SITE PLAN DEVELOPMENT PLAN
WARREN AVENUE TOWNHOMES

WARREN STREET TOWNHOMES
10209 East Warren Avenue
City of Aurora, Colorado, 80247

NOTES

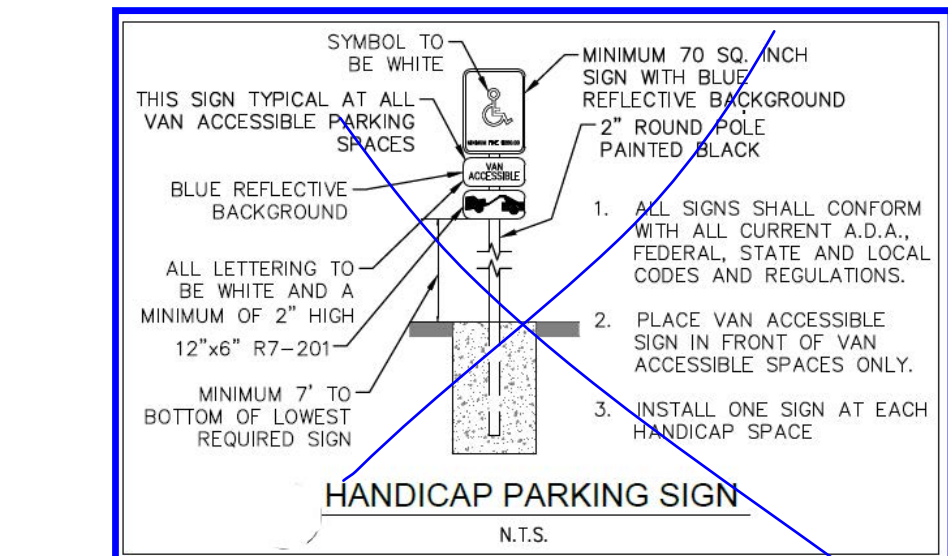
Repeat request to provide detail of mail kiosk. See note provided for an example.

The data block on the first page indicates you are providing one accessible parking space. Please indicate which space will be accessible and provide appropriate signage. Since you are providing one space, it must also be van accessible. Add detail provided.

This is pointing to the water service line

The accessible route does not need to be shown running parallel to the public right-of-way

Please make sure you can read all the text

Advisory comment: When it comes to civil this design of curb ramp will not be accepted. Having the sidewalk detached with this configuration is the preferred method

Type 5a. At the very top of the page it states "Do not use this design unless constraints, such as drainage structures, vaults, etc. require it; paired ramps are always preferred. Use only with City Engineer approval"

details added

HANDICAP PARKING SPACE PROVIDED detail added

revised

accessible route revised

curb ramps revised

curb ramps revised

GRADING AND DRAINAGE PLAN LEGEND

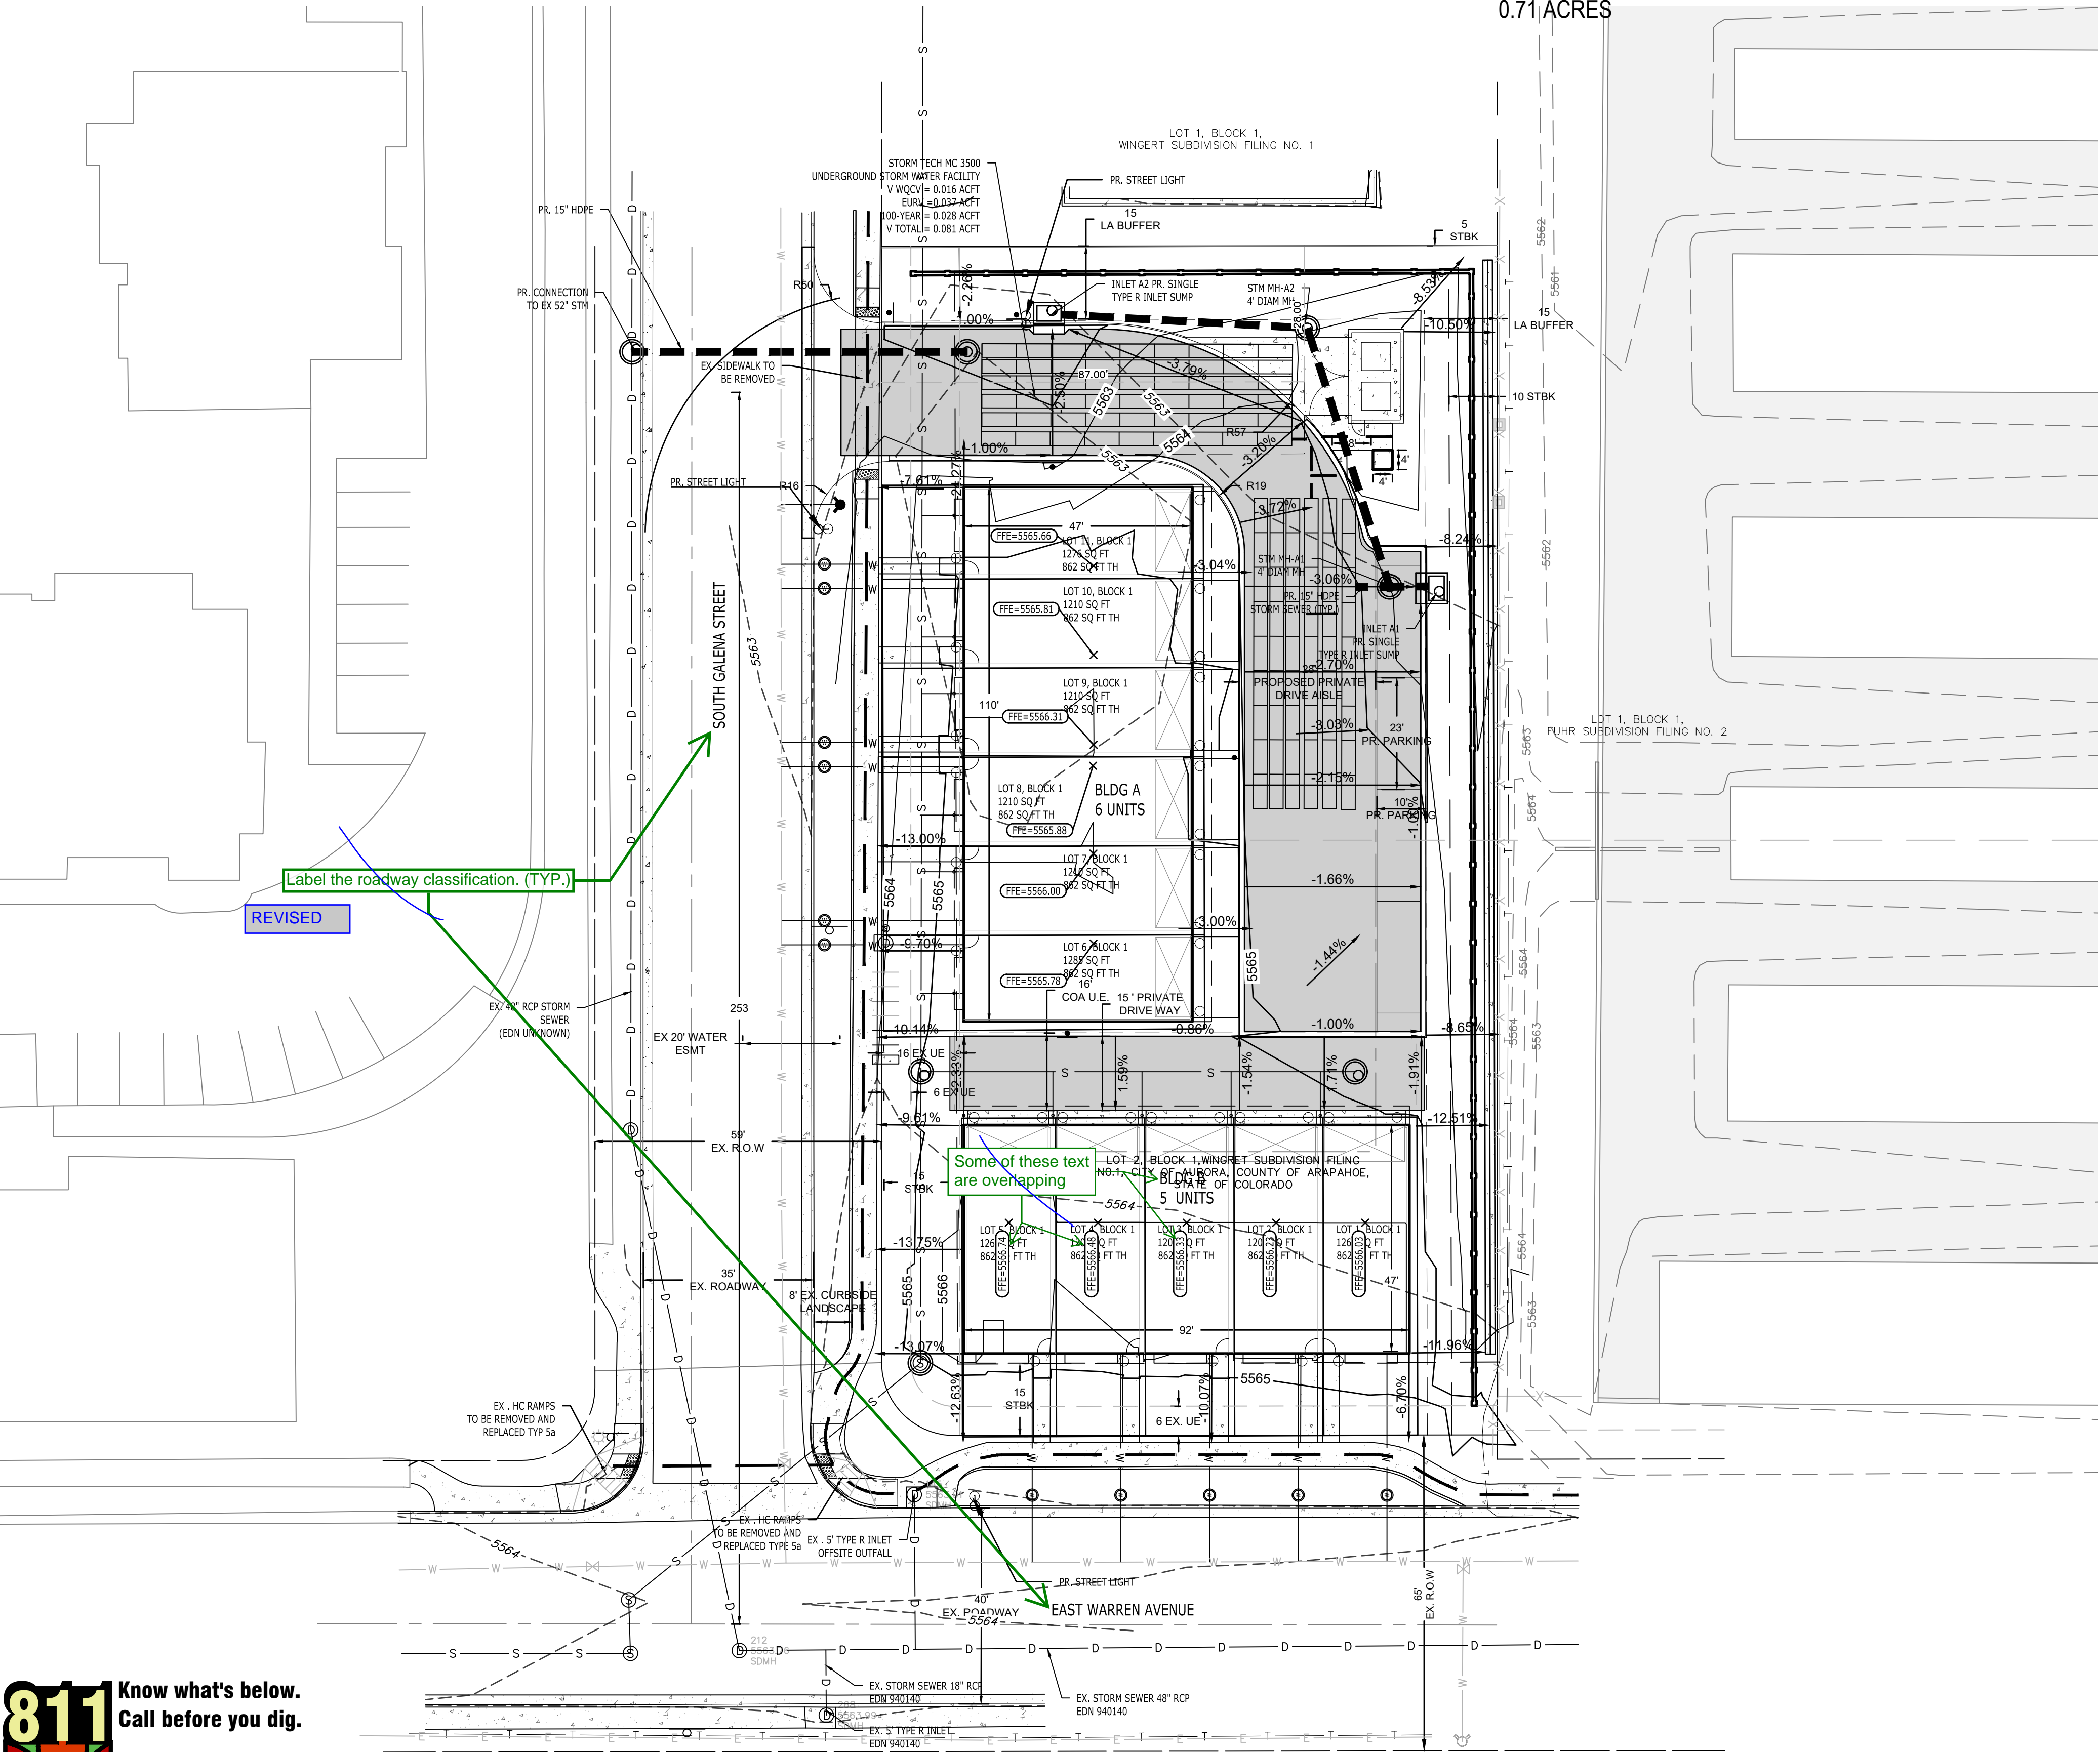
See notes on sheet 3
regarding accessible
route and provide
running and cross
slope/grade
percentages.

ADDRESSED

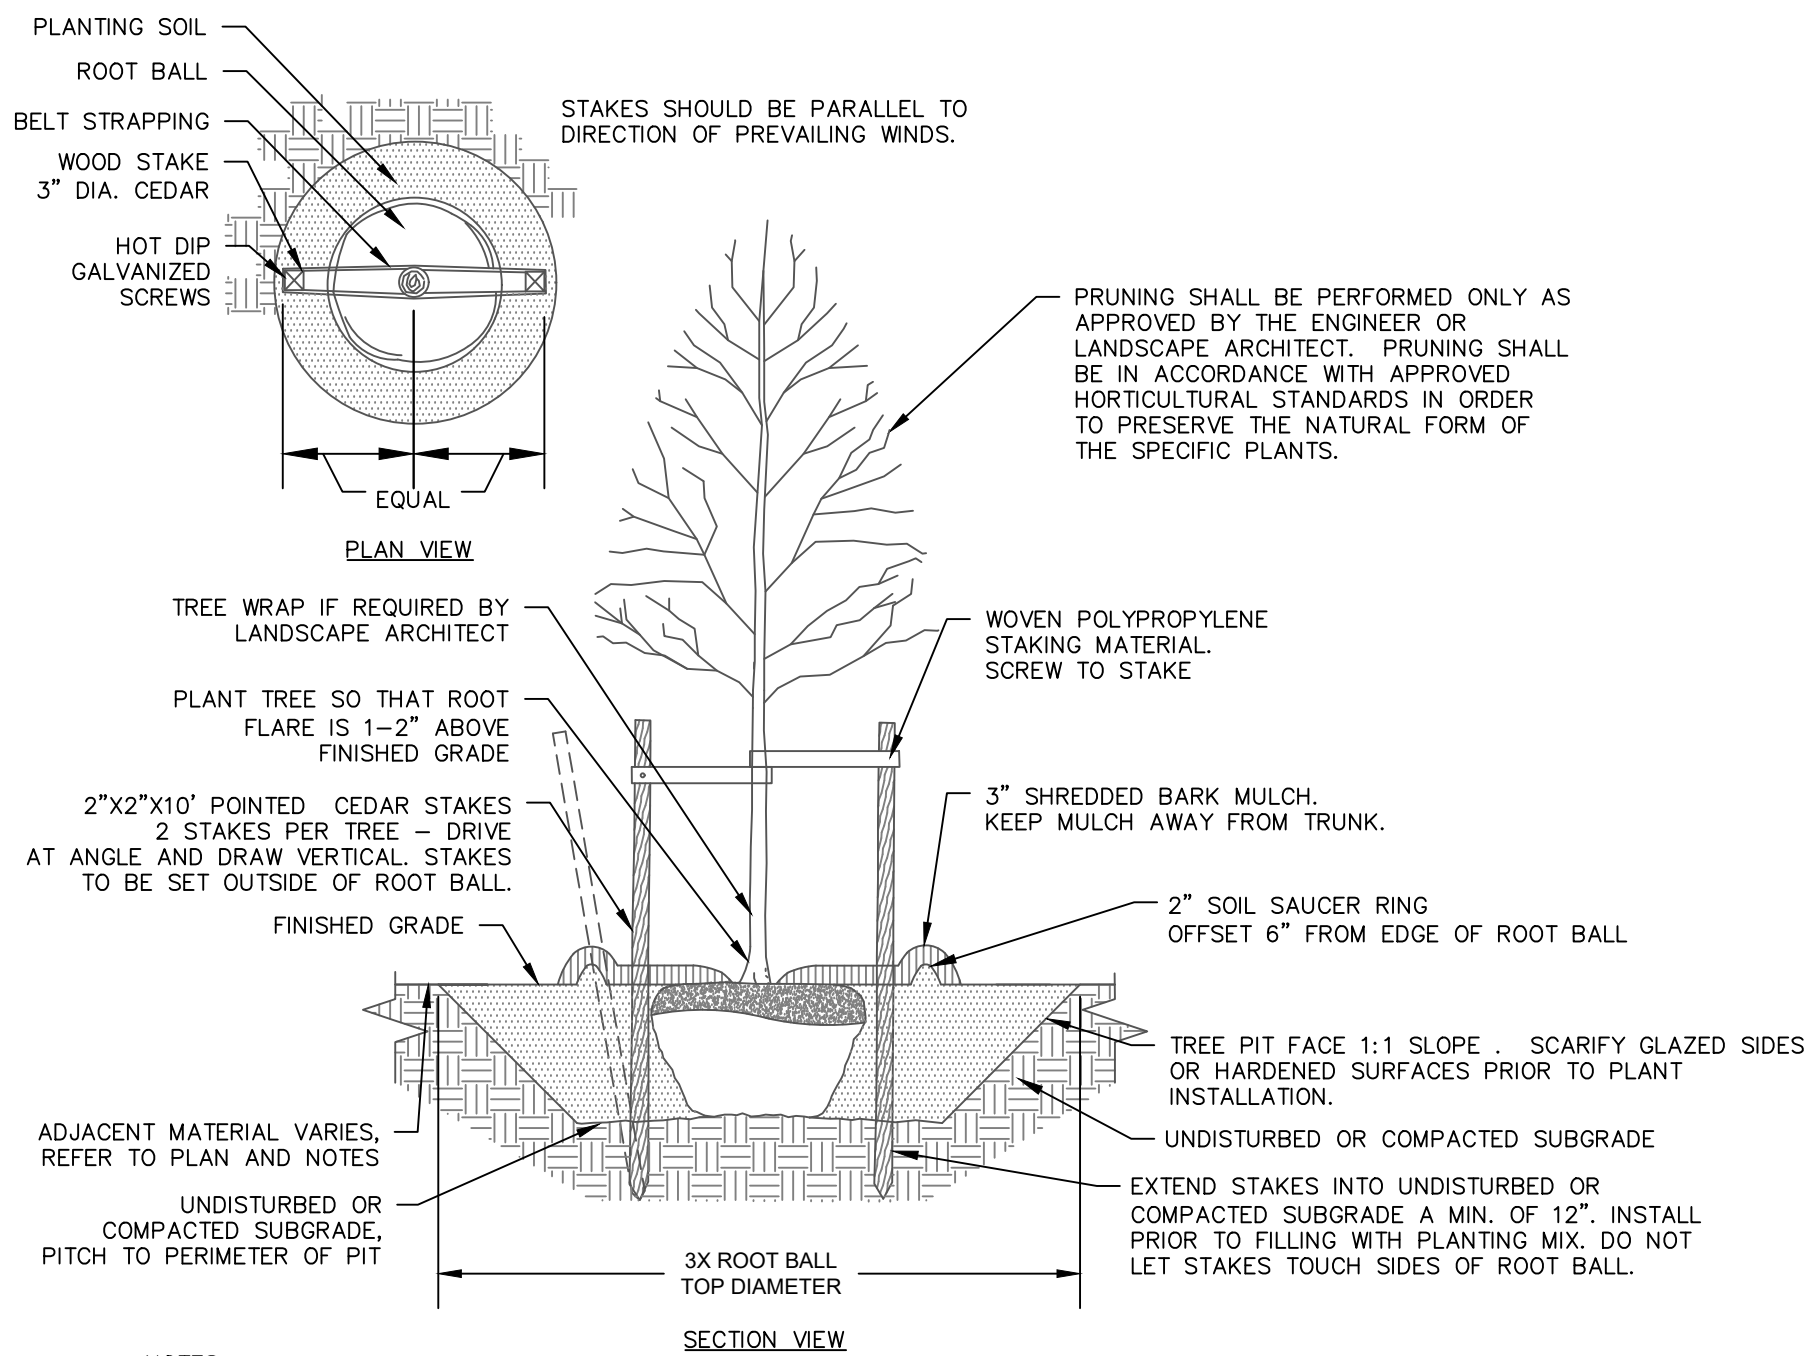
There are several trees that will be removed however they are in very poor condition and they do not require mitigation for these removed trees.

The adjacent property located to the north and east have several trees, which will most likely be impacted by this development. We are requesting that you send a certified letter to the adjacent property indicating the methods used to protect these trees as well as remedies as a result of potential damage incurred from the development. Please provide the City of Aurora a copy of this letter including the date sent and received.

where are they?

Turn the accessible route information off.

Darken

Label the mail kisok and trash enclosures.

Add diversity of plant material to this building. Some flowering shrubs perhaps Potentilla, or Knock Out Rose, or Bonica etc. This faces the street frontage. This is too uniform.

There is no space for maintenance and there is an existing fence on the adjoining lot. While code requires the landscaping for the buffer to be on the exterior side, shift all the landscaping on the interior side of the wall. Also, there is a 2' wide concrete pan that has not been included on the landscape plan along this wall. That will prevent the installation of plant material.

Trees that are being removed and mitigated should be included on a separate plan called Tree Mitigation Plan. The tree mitigation table would be included there as well.

Code only permits 40% of the total shrub requirement to be ornamental grasses and they must be 5 gallon. Excess may be provided as long as the shrub count is being met.

Turn off the accessible route.

It looks like RW is 3'-4" tall and in the sight triangle. That tall of a plant is not allowed to be in the sight triangle.

Ornamental grasses in the curbside area are required to be 5-gallon

While the scale below measures correctly, the drawing still appears to be off. Please see the measurements in red on the landscape plan.

Repeat comment: Add the written scale
